Location Address: 2027 Fletcher Street  
Lot(s): 11 Block(s): 3 Subdivision: SOUTH SIDE PARK

Explanation of Request: Developing 23- unit Multi-Family Apartments

**SUBJECT:** Preliminary Site Plan review for a 23-unit residential development. (2027 Fletcher).

C-1.1

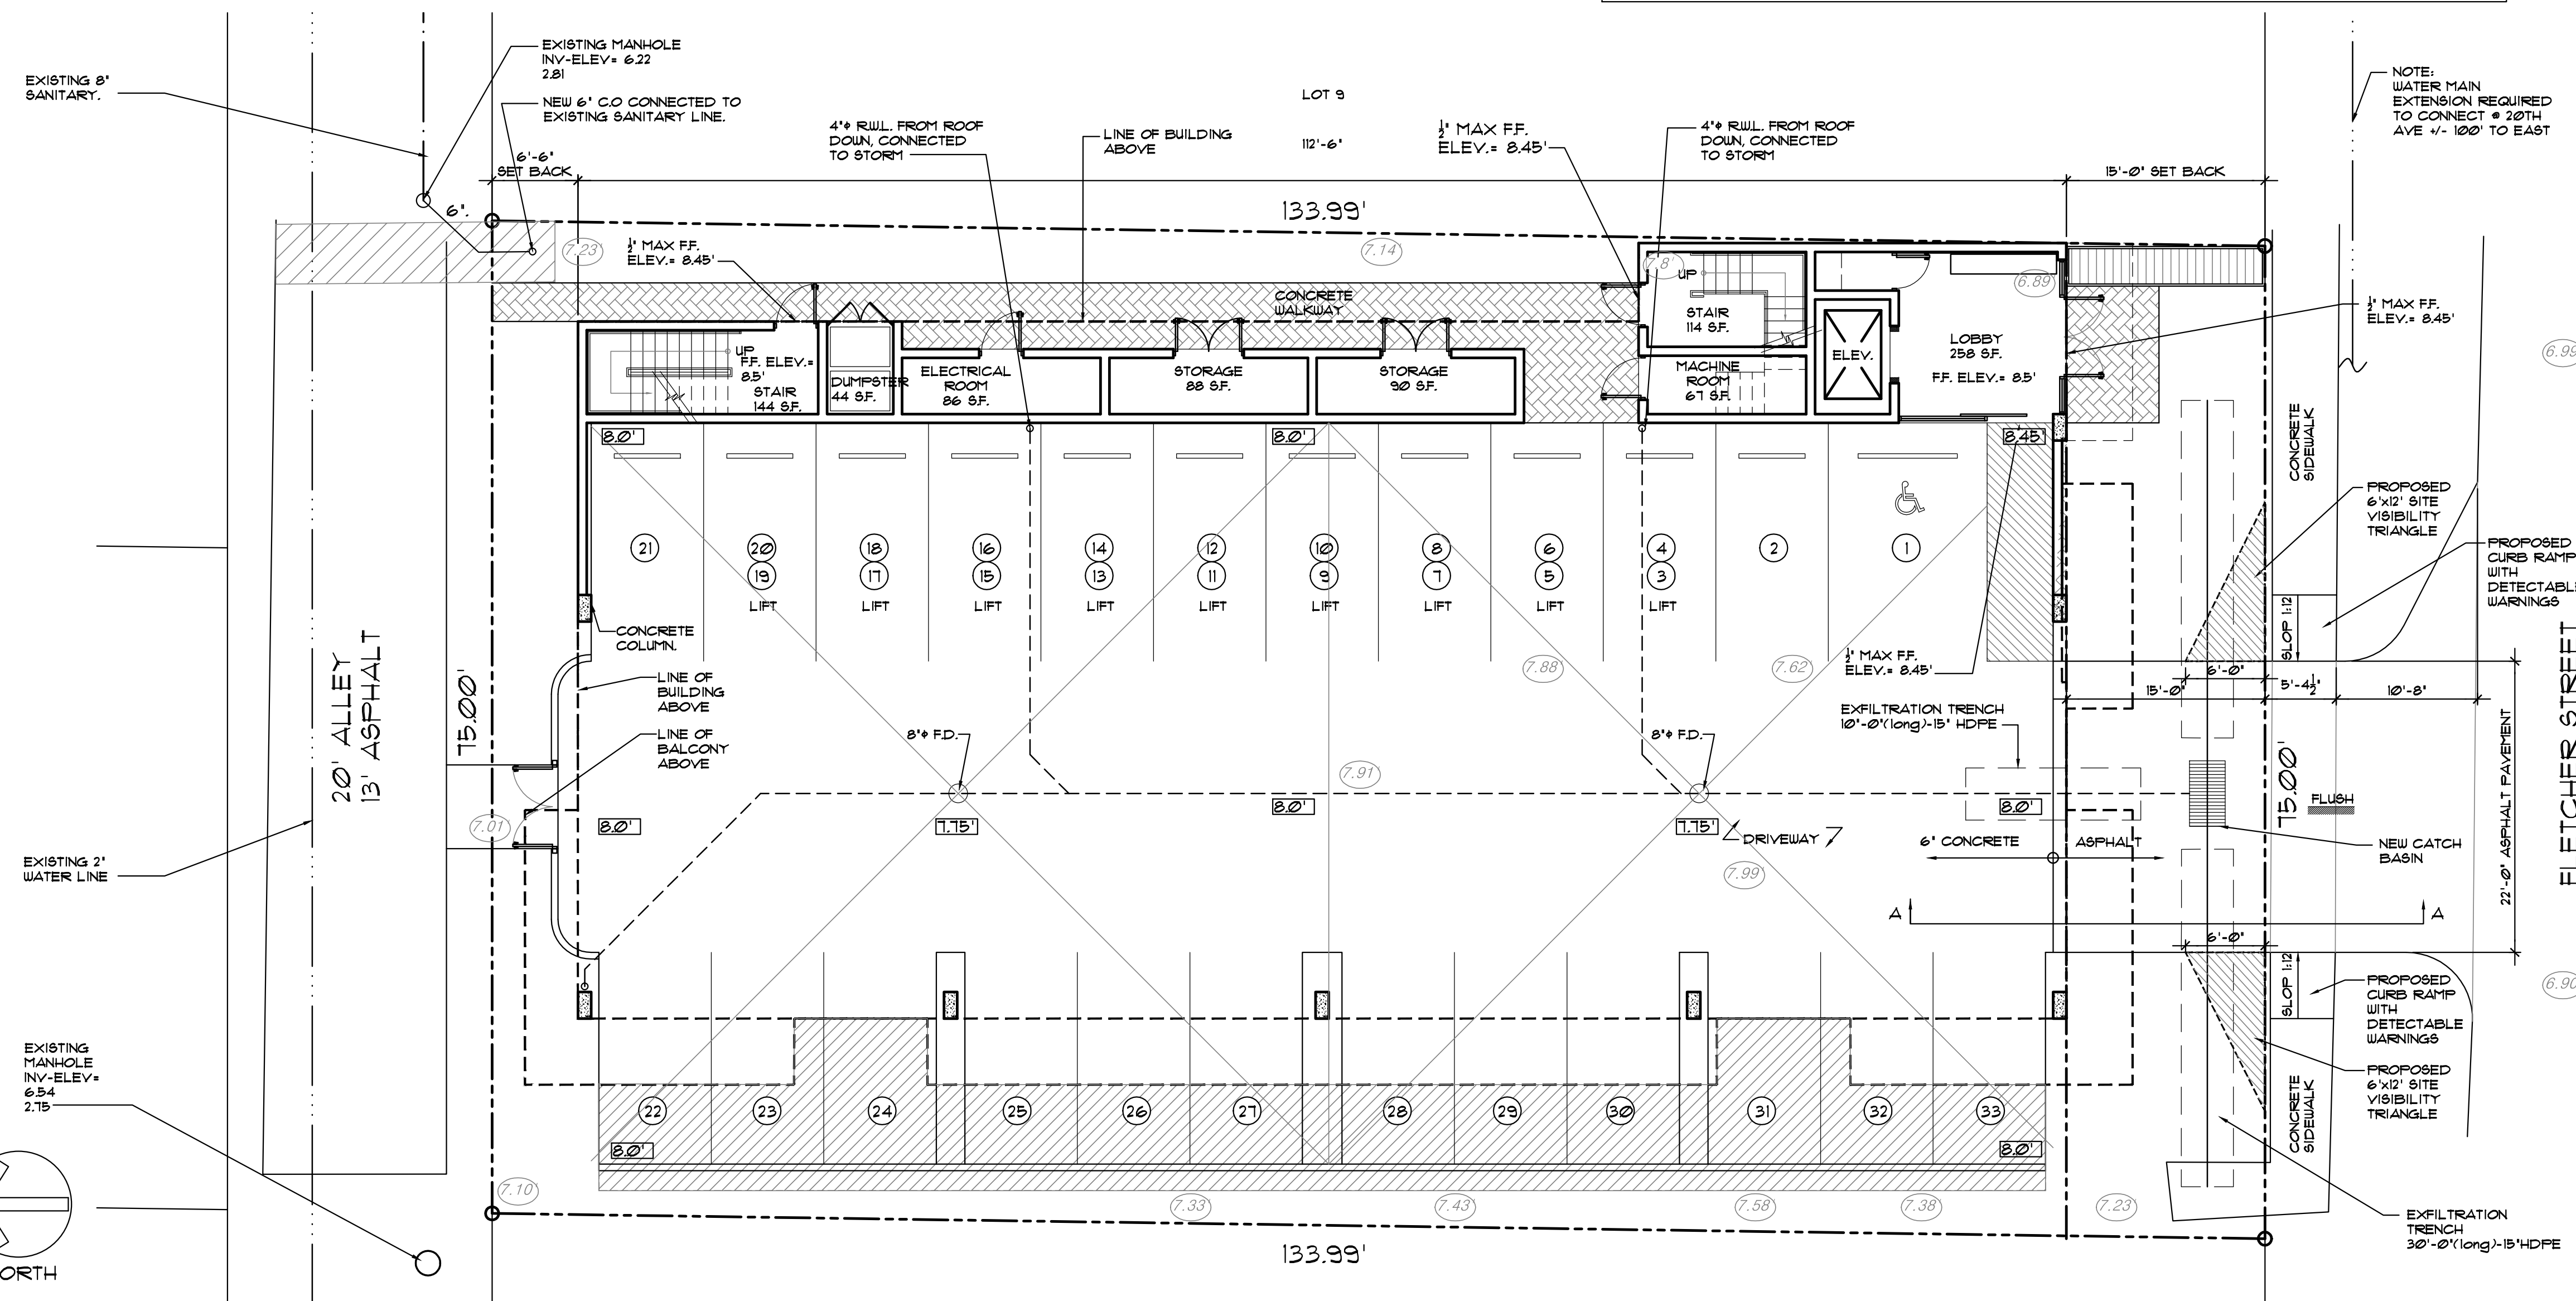
3. Provide full set of civil plans for the proposed work. Provide and indicate items such as but not limited to drainage improvements, curbing, all vehicle turning radii, sight triangles, pavement marking and signage plans and details as well as change in elevations to show that handicap accessibility has been met. For water and sanitary sewer connection, show any pavement restoration and details required for connections within City rights-of-way.

6. Provide civil engineering streetscape plans and plan details, showing proposed new sidewalks and curbs along Fletcher Street in front of the property.

3. Show existing site grades from survey on Sheet C-1.1.

4. Show perimeter cross sections across all property limits including transition areas meeting adjacent property grades with 6" swales to ensure all stormwater is retained onsite.

3. No civil drawings were turned in for the underground fire main. Provide such including location of fire department connection, DDCV, and size of fire line from water supply. Check with our water department engineer for city requirements in addition to fire. Ensure plans that there is a fire hydrant within 100 feet of fire department connections.

4. Provide a note on civil drawing all underground fire main work must be completed by fire protection contractor holding a Class I, II, or V license per FS 633.102.

6. Per NFPA 1, 12.3.2\* a quality assurance program for the installation of devices and systems installed to protect penetration and joints shall be prepared and monitored by the registered design professional responsible for design. Inspections of fire stop systems and fire-resistive joint systems shall be in accordance with 12.3.2.1 and 12.3.2.1. Architectural plans will be required to show this information moving forward for buildings three stories or greater in height. Provide a note on the plan regarding NFPA 1, 12.3.2\*.

7. It was noted on the plan, there may be stacked car parking. Be advised, the fire sprinkler system will need to be designed as Extra Hazard, Group II. Provide a note on the plan as such.

***Response: Refer to C-1.1***

***Response: Refer to C-1.1***

### ***Response: Refer to C-1.1***

***Response: Refer to C-1.1***

***Response: Refer to C-1.1***

***Response: Refer to C-1.1***

***Response: Refer to C-1.1***

***Response: Refer to C-1.1***

SP-1.1  
OF SHEETS

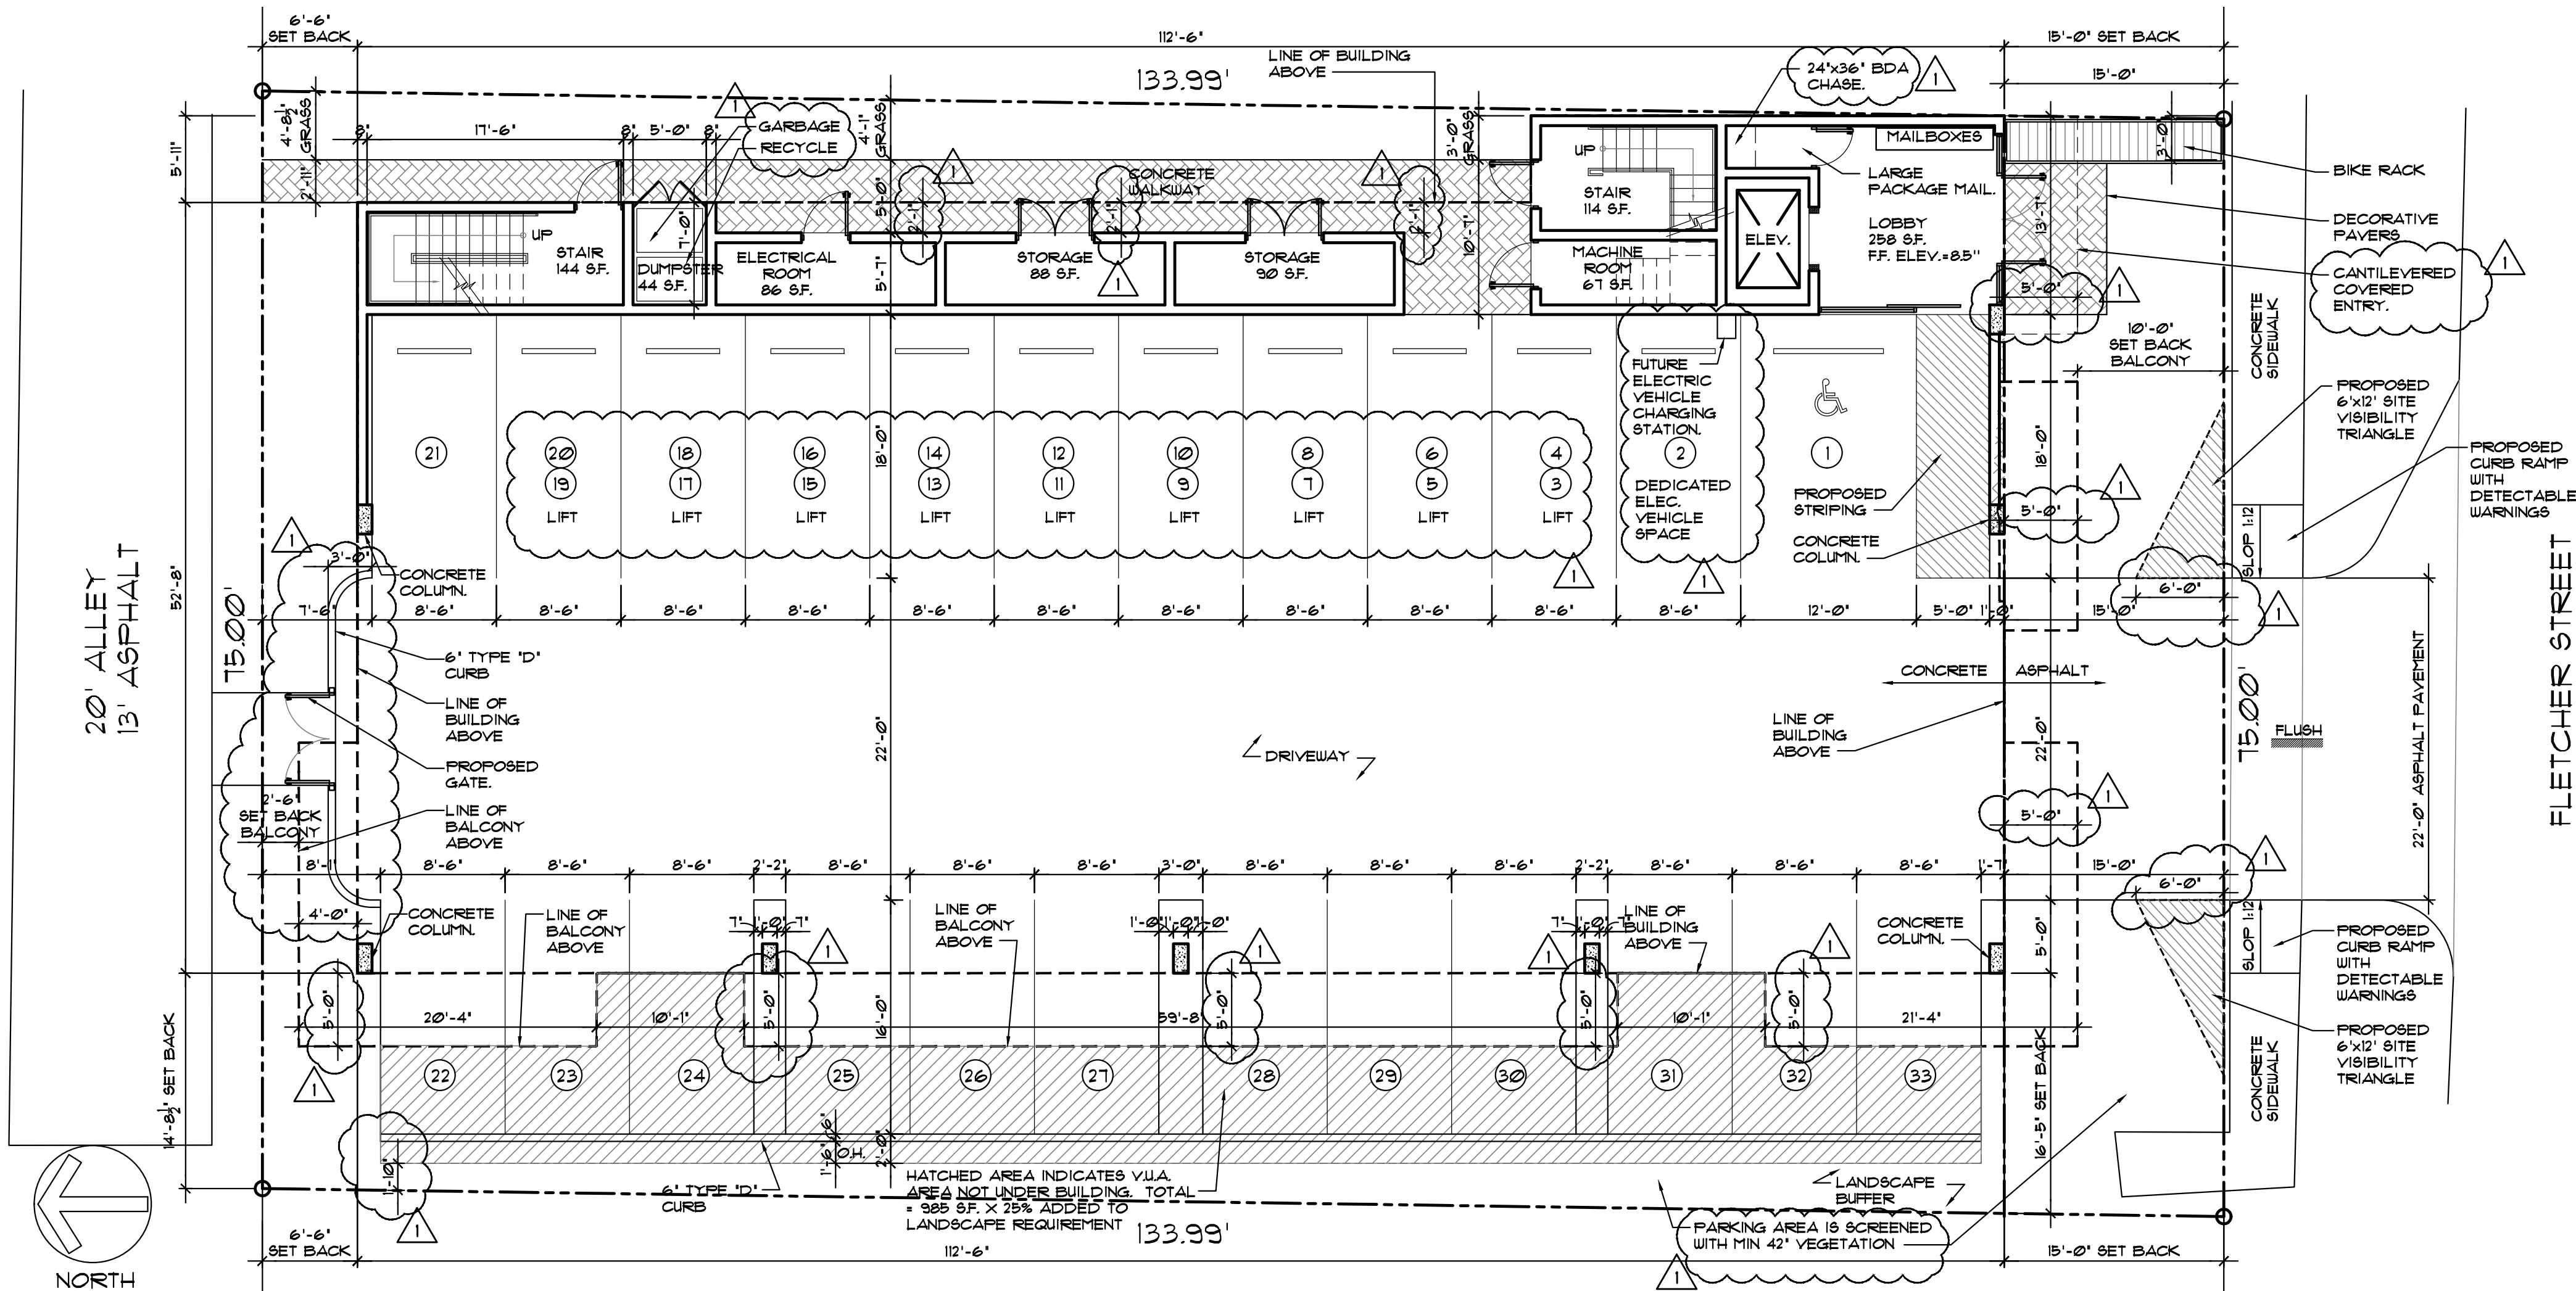
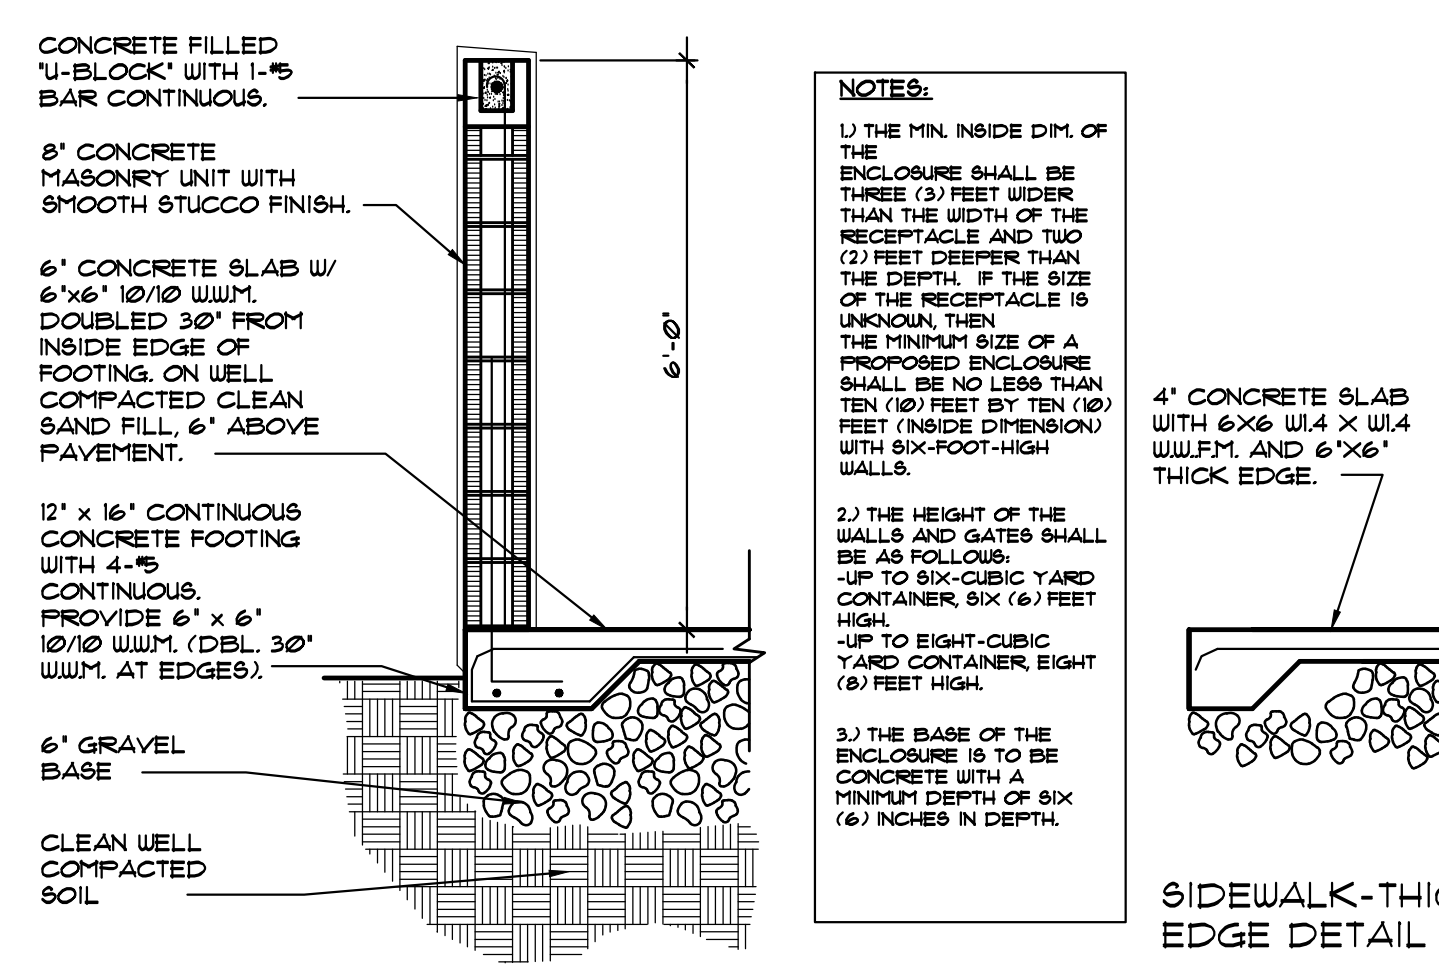
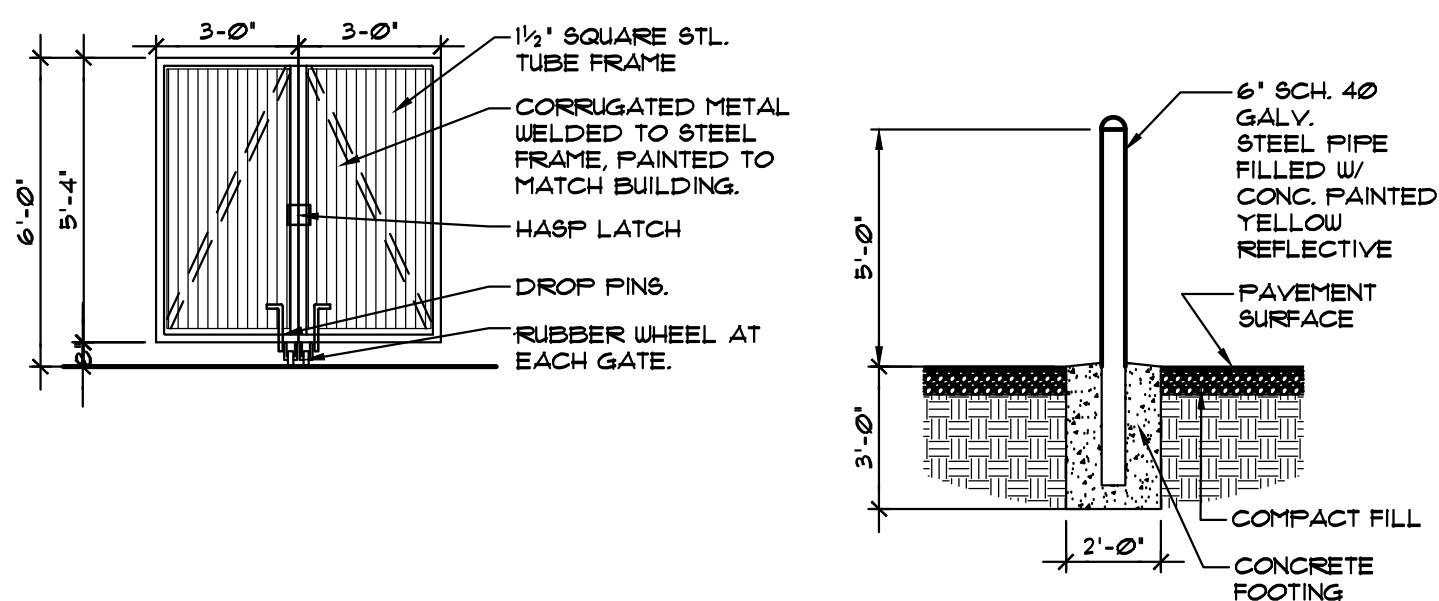
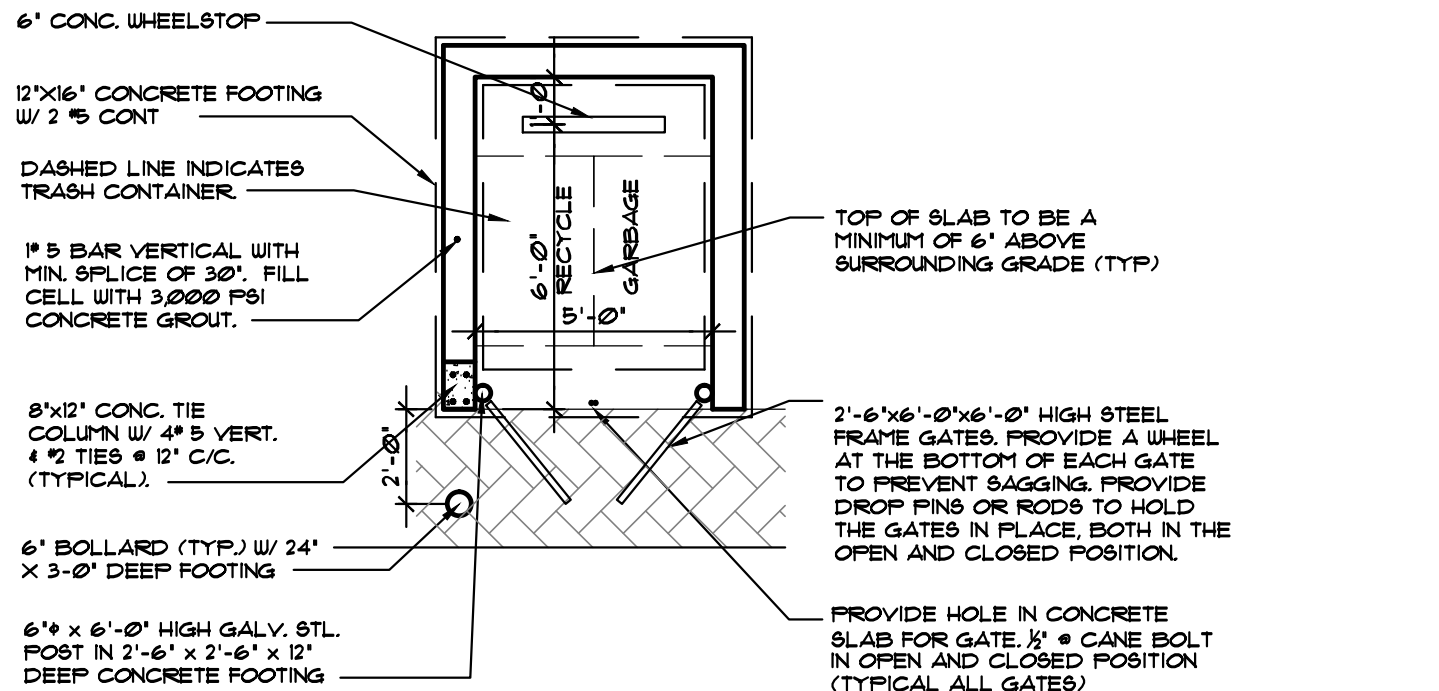
- a. Provide the depth of dumpster enclosure.

5. Site Data:
  - a. Ensure that legal description matches Alta Survey and O&E exactly.  
**Response: Revised**
  - b. Net area shall match survey in next submittal; ensure FAR is updated accordingly.

**Response: Revised on SP-1.1.**
  - c. Provide required and proposed minimum and average unit size.  
**Response: Revised on SP-1.1**
  - d. Under allowable height, indicate the property is within 100' of PS-1 therefore max height is 55 feet.

1. Show on plans how ADA accessibility requirements are met. ADA accessible route is required between accessibility parking and building access. Show in your plans all change in elevation and slopes in this area.

4. Garage required 1 Van-Accessible ADA Parking Spaces with access aisle located in the right side of the parking. Identify location in the plans.

5. Show garage entrance elevation: Van accessible: 8'-2"

10. Indicate location of mail boxes/services on plan.

12. Show view triangle of 6'x12' in sheet SP-1.1. The view triangle is an area delineated by a line connecting points measured 12 feet distant along property line from the interception of the access way and 6 feet distant along the access way. See COH Code of Ordinances for diagram.

***Response: Refer to SP-1.1***

**Response: revised on SP-1.1**
  - e. Include at grade parking setbacks in chart.  
**Response: Provided on SP-1.1.**
6. Complete and submit to Broward County School Board an impact fee application prior to submitting for Board consideration. Website:  
<http://www.broward.k12.fl.us/propertymgmt/new/growthmanagement/docs/PublicSchoolImpactApplication.pdf>

***Response: Refer to SP-1.1***

***Response: Refer to SP-1.1***

***Response: Refer to SP-1.1***

***Response: Refer to SP-1.1***

***Response: Provided on SP-1.1 and C-1.1***
